Attention: Periodic Review Specialist  
Department of Land Conservation and Development  
635 Capitol Street NE, Suite 150  
Salem OR 97301

I am writing to raise objections to the Metro decision to add the Sherwood West Urban Reserve to the Urban Growth Boundary. Specifically, I object to the inclusion of the industrial designation on the north portion of the Sherwood West expansion. In addition, I object to the representation of Elwert Road as a “Residential Boulevard”. I also object to the depiction of an existing neighborhood as the pathway of a conceptual connector. Remedies to these objections would consist of removing the Sherwood West north subdistrict from the expansion proposal. In addition, the expansion proposal should accurately represent an expanded Elwert Road and remove any reference to a conceptual connector.

**Date:** November 4, 2022  
**Project:** Sherwood West Concept Planning  
**To:** Erika Palmer, Planning Manager  
**From:** Bob Galati P.E., City Engineer  
**Topic:** Alignment/Grade Analysis of N-S Road

**SHERWOOD WEST CONCEPT PLAN  
NORTH-SOUTH 3-LANE ARTERIAL  
ROAD ALIGNMENT ANALYSIS  
PLAN VIEW**

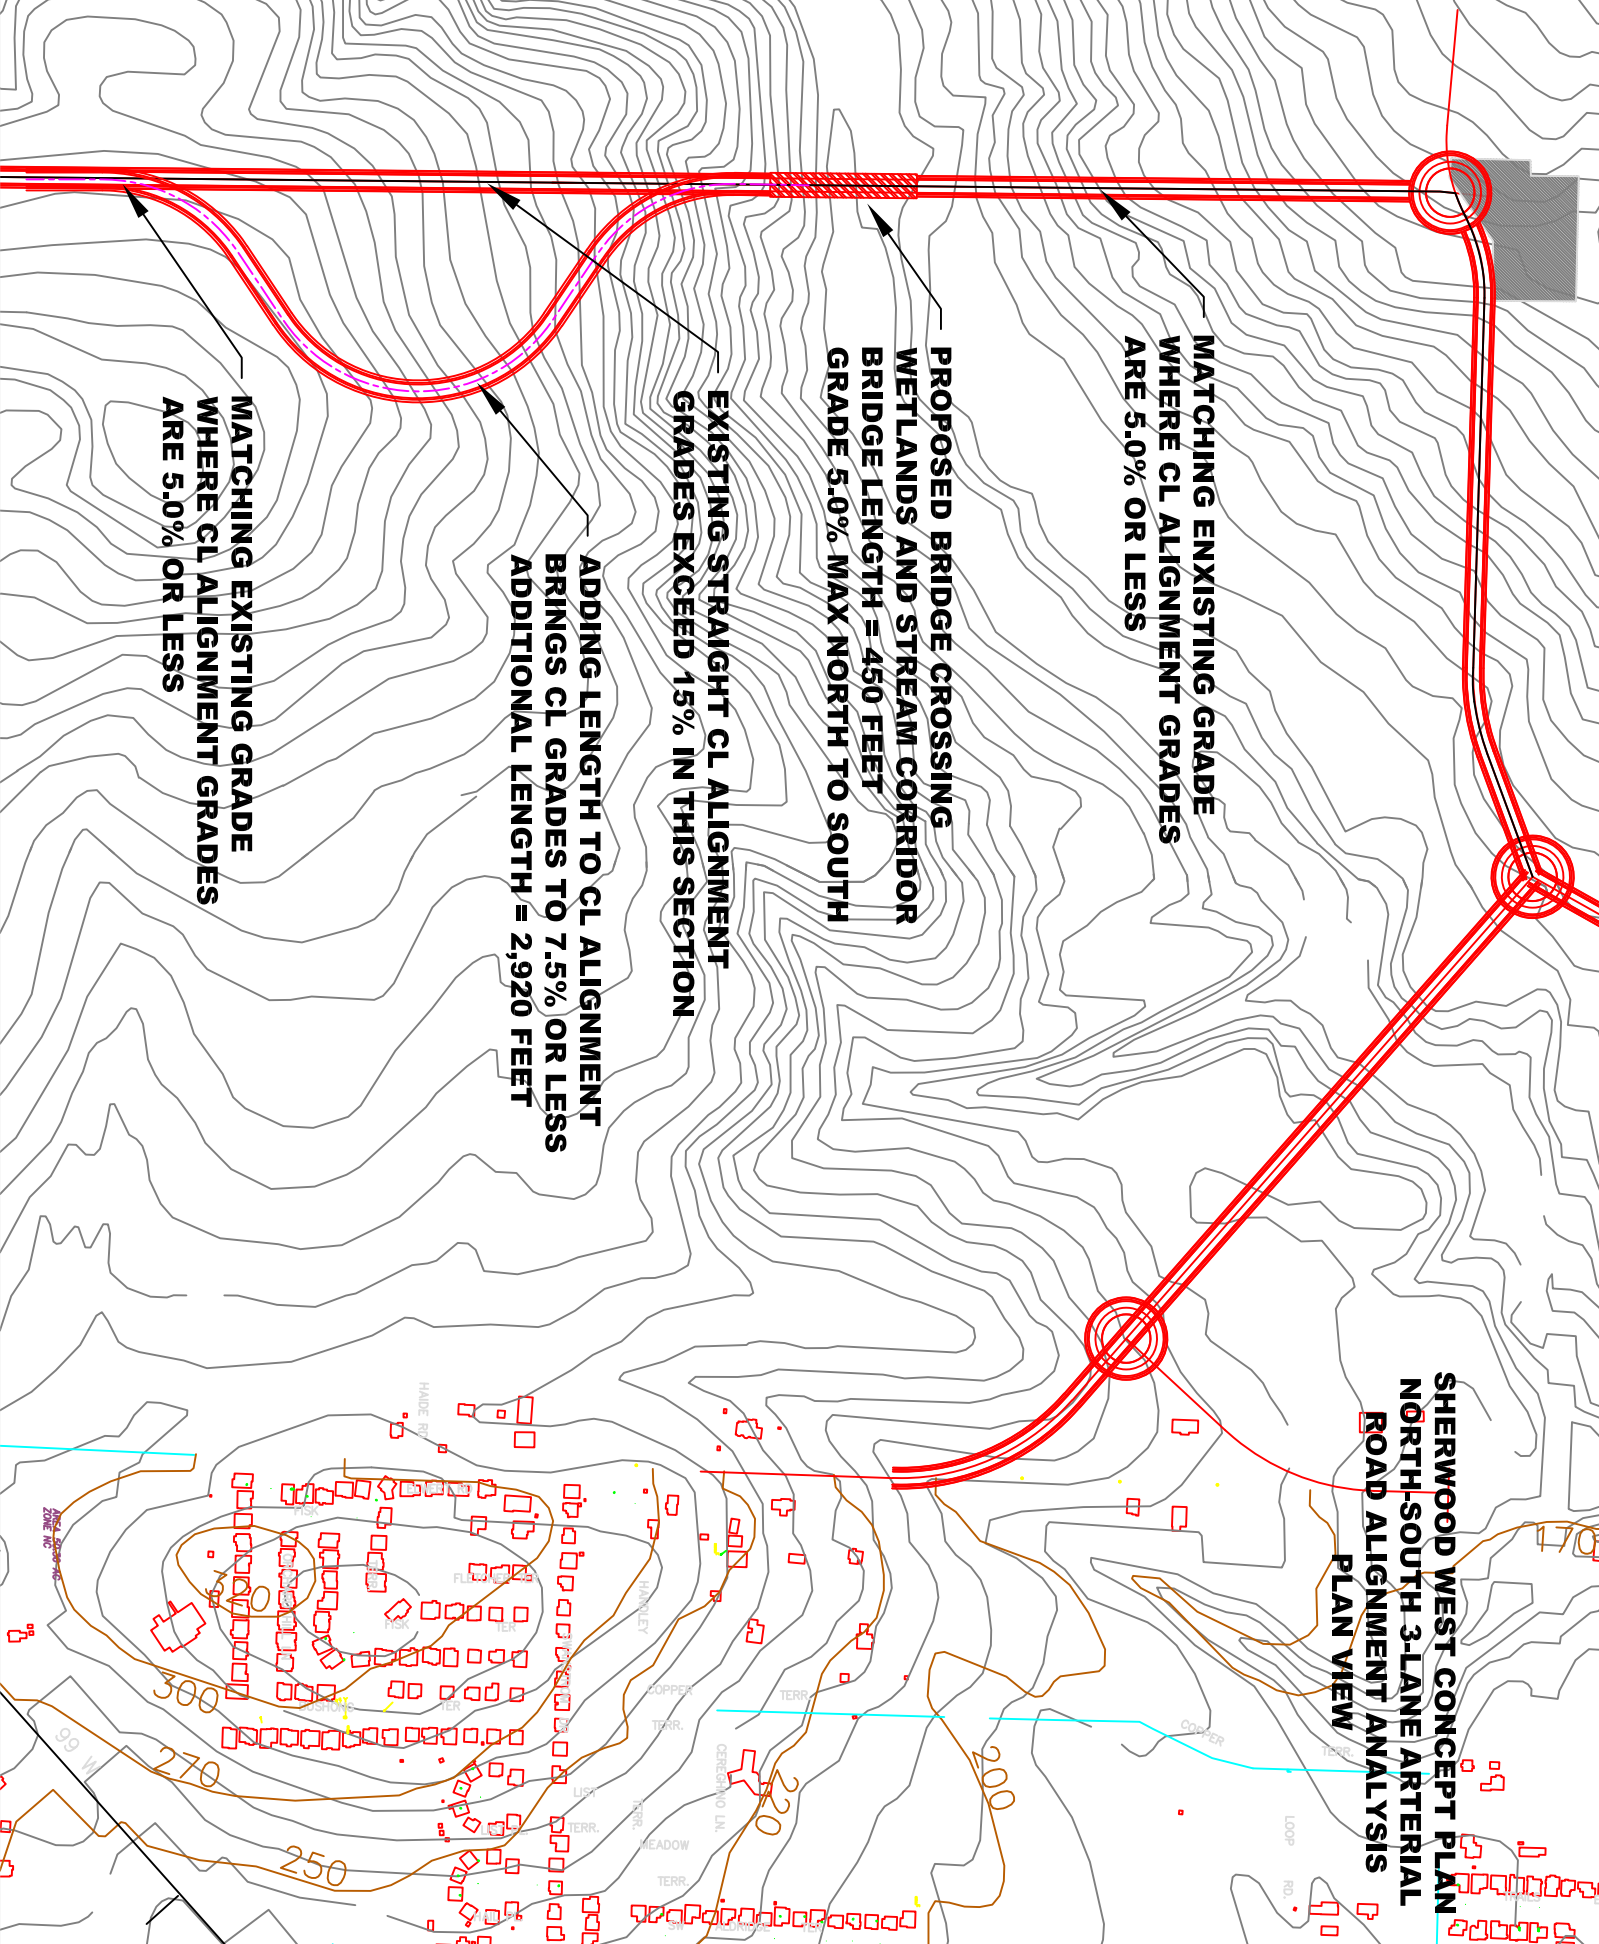
- Mr. Galati's memo contains no description of the existing neighborhood on Eastview Road.
- The map included in Mr. Galati's memo, showing the North-South 3 Lane Arterial shows all the structures near Elwert Road and none of the existing homes on Eastview Road or Edy Road.

- Mr. Galati characterizes the proposed truck route as “impact(ing) the fewest number of structures.”
- In fact, a careful review of Mr. Galati’s plan shows that 9 houses would end up being removed and 4 houses in the Rural Reserve would lose access to Eastview Road.
- Mr. Galati does not acknowledge that the intersection of Edy and Eastview Road is a dangerous S-Curve with some of the highest rate of accident occurrences in Washington County.
- Mr. Galati does not acknowledge the environmental damage that can be expected with a project that lays down 76,000 Cubic Feet of fill near Chicken Creek.

The assertions I am making can be directly obtained by reviewing the implications of Mr. Galati’s Road Alignment Analysis on page 41 of the CAC Meeting #11 Packet.

- The proposal to add enough fill over the course of Eastview Road to change a 12% slope to a 7.5% slope would have a devastating impact on the neighborhood. The amount of fill necessary to accomplish this is extraordinary. The volume would be 76,000 cubic yards or 7,600 dump truck loads. This would be 21 dump trucks a day for a year to deliver this volume of fill.

- The project would involve construction of a new 450-foot-long bridge over Chicken Creek.
- The project will require a 150 foot right of way to accommodate 3 lanes of traffic, two sidewalks, 2 guardrails, fill slopes and two fences at the toe of both fills.

- The impacts of the bridge, road elevation described, and necessary right of way, would wipe out 9 houses.
  - Several homes on the east side of Eastview Road are less than 150 feet from the western side of the right of way.

- Due to the width of the right of way for this volume of fill, 5 homes would be in the direct path of the right of way.
  - Two additional homes would have their access cut off and have a three-lane truck route on their doorsteps, and 40 feet above them.

- One home would be removed to improve the dangerous Edy-Eastview intersection.
  - One home, which is on the west side of Eastview Road in the Rural Reserve, would be removed by bridge construction.

- In addition, raising the elevation of Eastview Road would eliminate access to 4 homes in the rural reserve to the west of Eastview Road.
